AREVA Enrichment Services LLC
Eagle Rock Enrichment Facility
NRC Docket No: 70-7015

Subject: Notice of Organization Change for the Eagle Rock Enrichment Facility
License Application

Attachment 1 – AES Organization Change, Marked-up Pages for the Safety Analysis Report and Quality Assurance Program Description

Figure A-2 **Rev. 1a**
Engineering, Procurement and
Construction (EPC) Organizational Chart
EAGLE ROCK ENRICHMENT FACILITY
QUALITY ASSURANCE PROGRAM DESCRIPTION

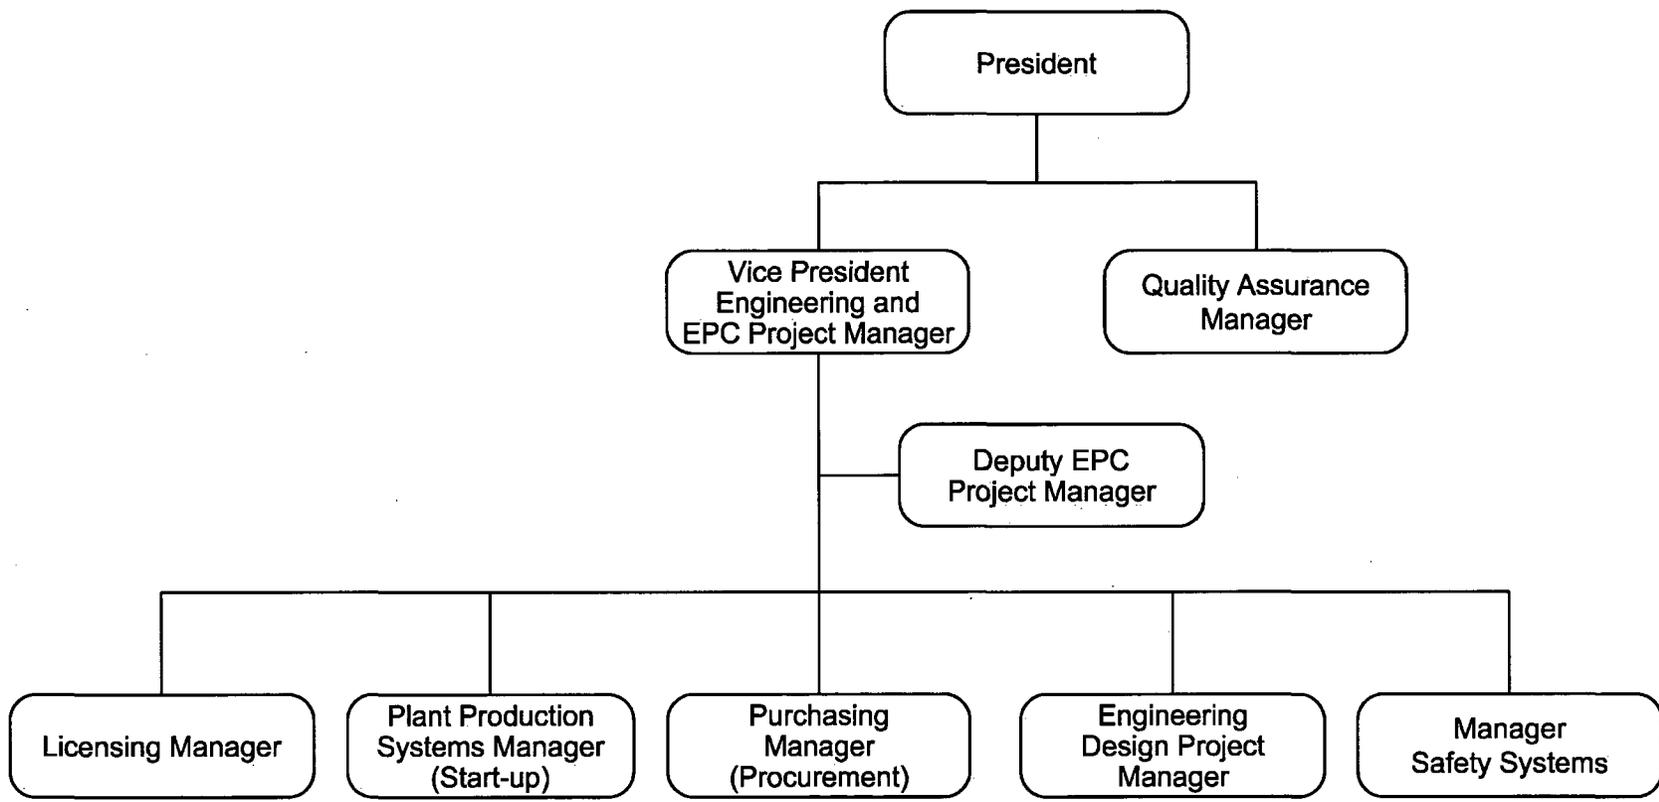
1.1.3 Figure A-2 of the QAPD shows the engineering, procurement, construction, and initial start-up organization of the EREF.
